2. SITE CHARACTERISTICS

2.1 Introduction

Figure 2.4.3-1 Depth-area-duration curves prepared for bracketing North Anna drainage area. The dotted horizontal line corresponds to a drainage area of 343 mi², equal to that of the North Anna Dam.

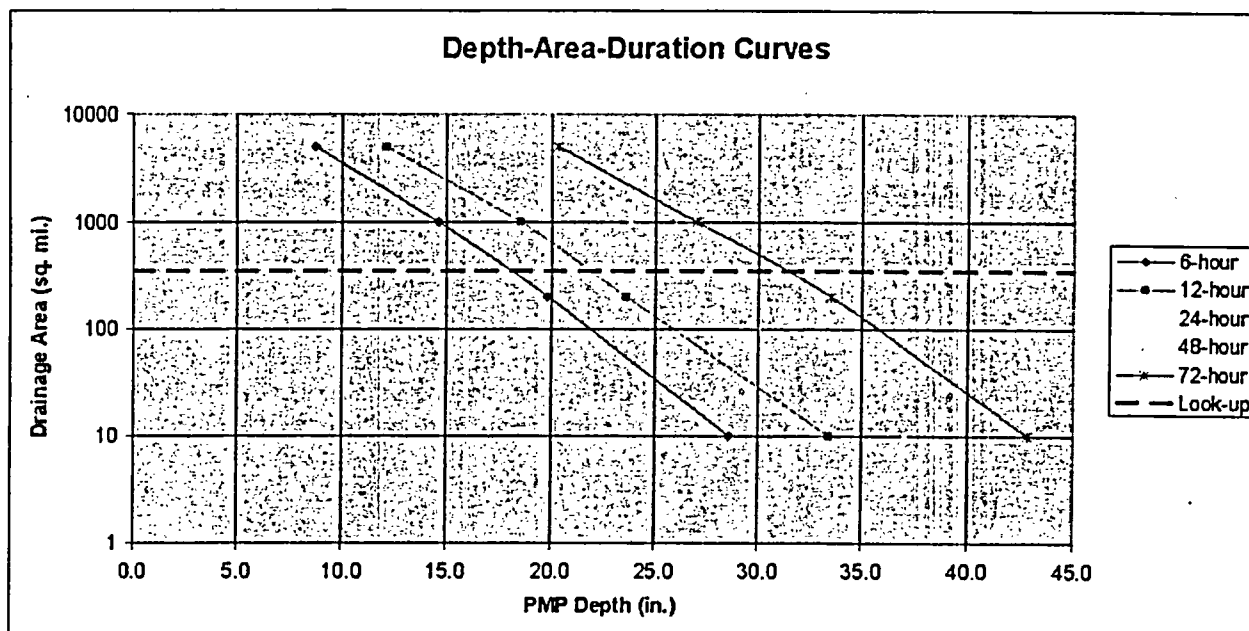
Using the values in Table 2.4.3-1, the staff prepared depth-area-duration curves following the guidelines of HMR 51 to bracket the drainage area of Lake Anna. Figure 2.4.3-1 illustrates these depth-area-duration curves. The staff determined PMP depth values corresponding to the North Anna Dam drainage area of 343 mi² from Figure 2.4-1 to construct Table 2.4.3-2.

Figure 2.4.3-4 Applicant's original (black line) and staff's conservative (red line) unit hydrographs

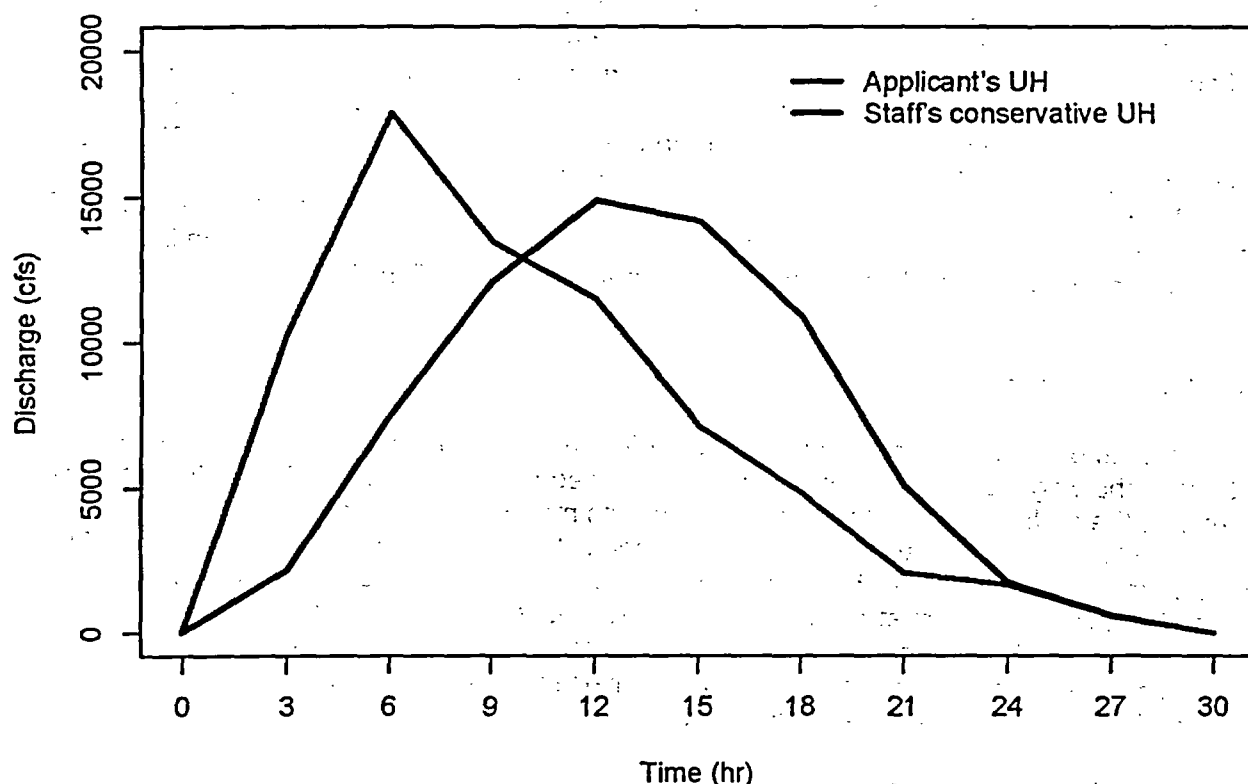
The staff also determined that, for computing floods from PMP, unit hydrograph flood peaks should be increased from 5 to 20 percent, and the time to peak should be reduced by 33 percent (Linsley, et al., *Hydrology for Engineers*, 3rd Edition, 1982; Pilgrim and Cordery, "Flood Runoff," Chapter 9 in *Handbook of Hydrology*, 1992). The staff adjusted the applicant's unit hydrograph according to these guidelines to provide a more conservative estimate of the unit hydrograph than that used by the applicant. Figure 2.4.3-4 illustrates the staff's conservative and the applicant's original unit hydrographs. The peak discharge in staff's conservative unit hydrograph is 20 percent greater than that in applicant's unit hydrograph, and

the time to peak in staff's conservative unit hydrograph is reduced by 50 percent compared to that in applicant's unit hydrograph.

Figure 2.4.5-1 North Anna Power Station site and fetch length

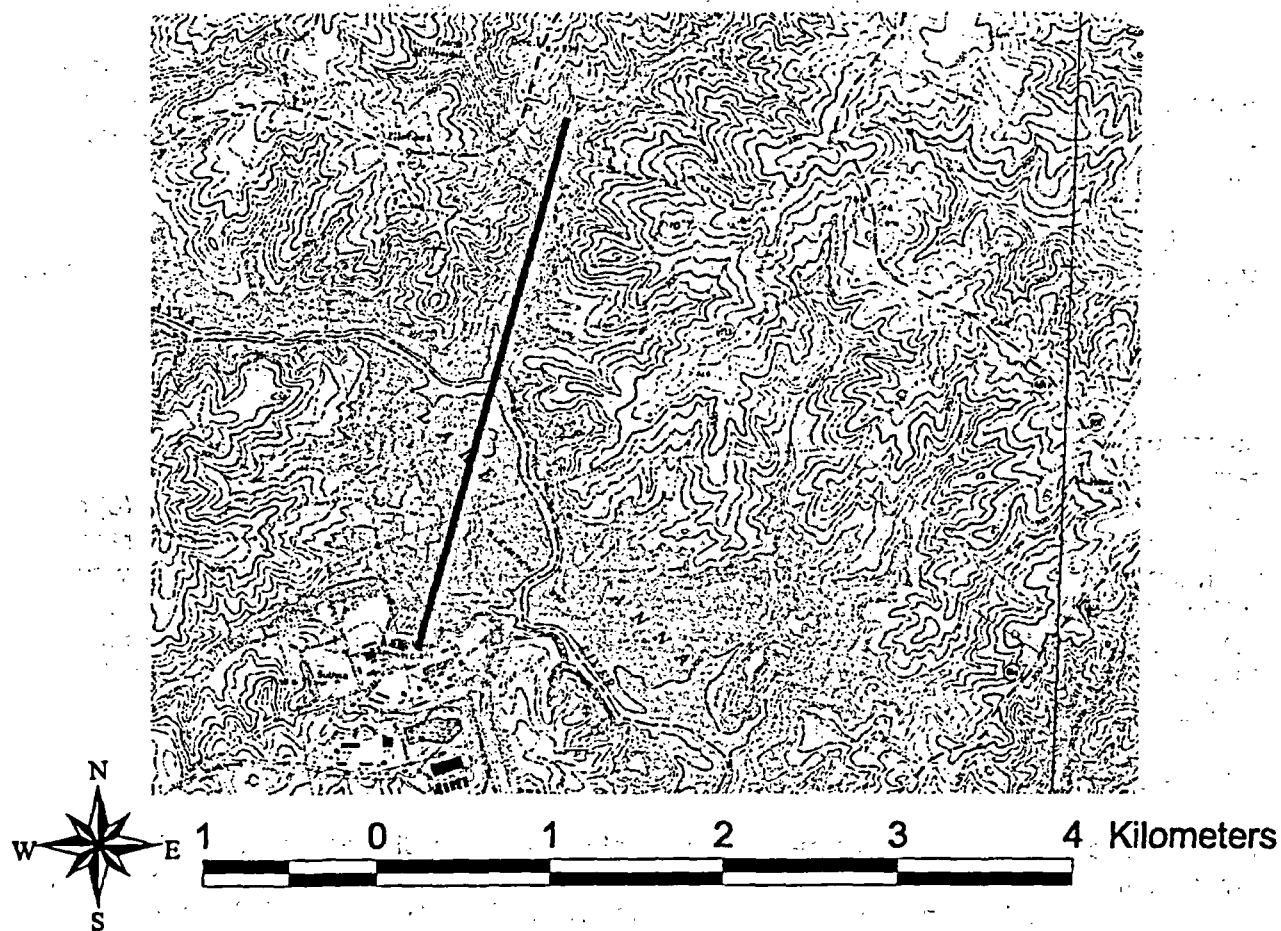
The following describes the staff's independent evaluation to estimate seiche effects. Fetch length is one of the key parameters for determining wind setup, and it is generally based upon the longest straight-line distance to the opposing shore. Although the ESP site is 5 miles from the North Anna Dam and more than 10 miles from the upstream end of the reservoir, the longest straight-line distance to the opposing shore is approximately 2 miles (see Figure 2.4.5-1).

The staff estimated the period of oscillation caused by seiche along the fetch length line shown in Figure 2.4.5-1 based on the theory for free oscillation of water of uniform depth in a rectangular basin (Wilson, "Seiches," *Advances in Hydrosience*, Volume 8, 1972):

Figure 2.4.6-1 Landslide diagram resulting in wave traveling towards the ESP site. The 70 ft segment indicated in blue is the distance from the shore to the thalweg and represents that part of the water column displaced by the landslide.

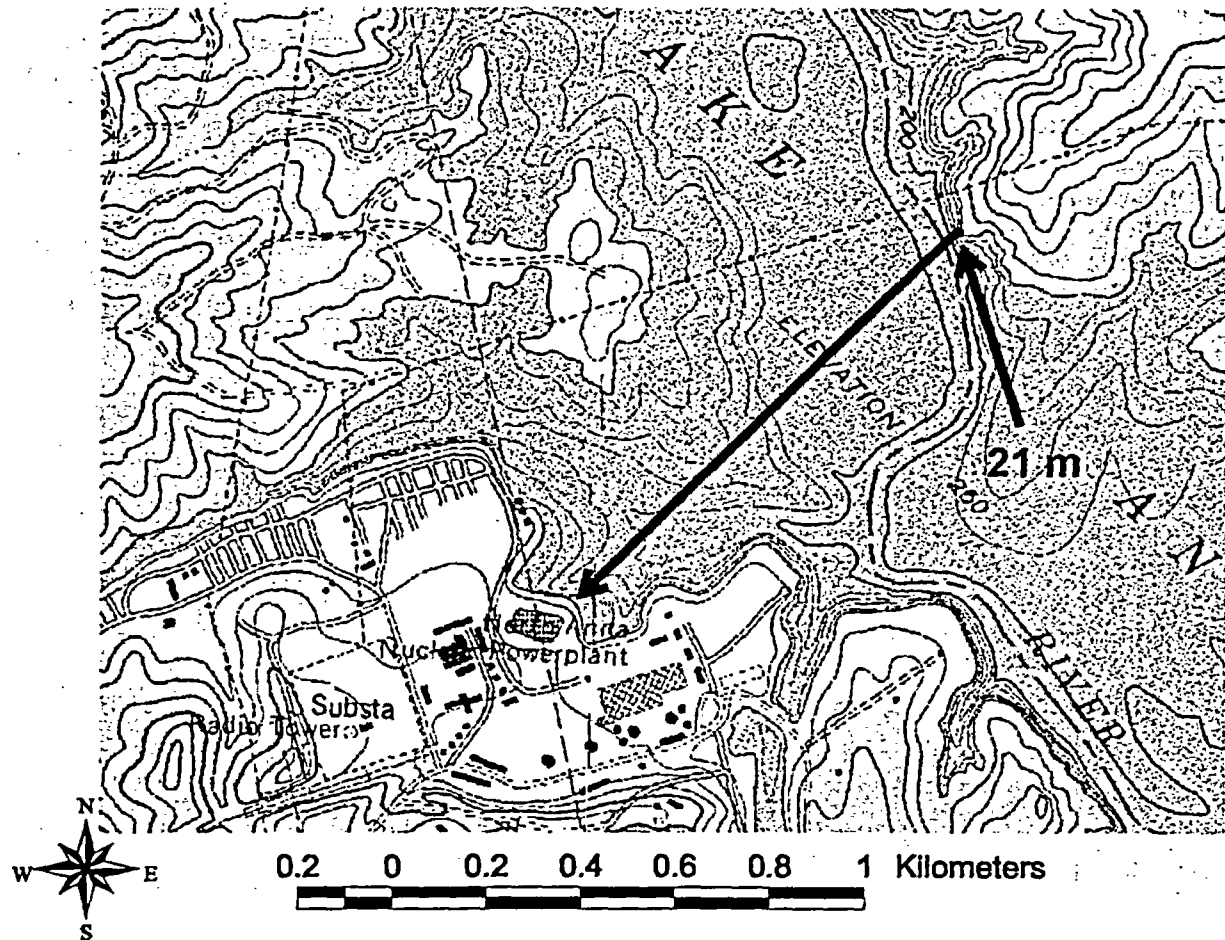
level in Lake Anna, a landslide could therefore fall 50 ft before hitting the water. If drag is neglected, an object falling from the hilltop could reach a vertical speed of approximately 55 ft/s. The staff conservatively assumed that such a hillslope failure might result in a horizontal water wave of the same speed. In addition, the staff conservatively assumed that this landslide would displace water from the existing shoreline to the deepest portion of the lake approximately 70 ft offshore (see Figure 2.4.6-1).
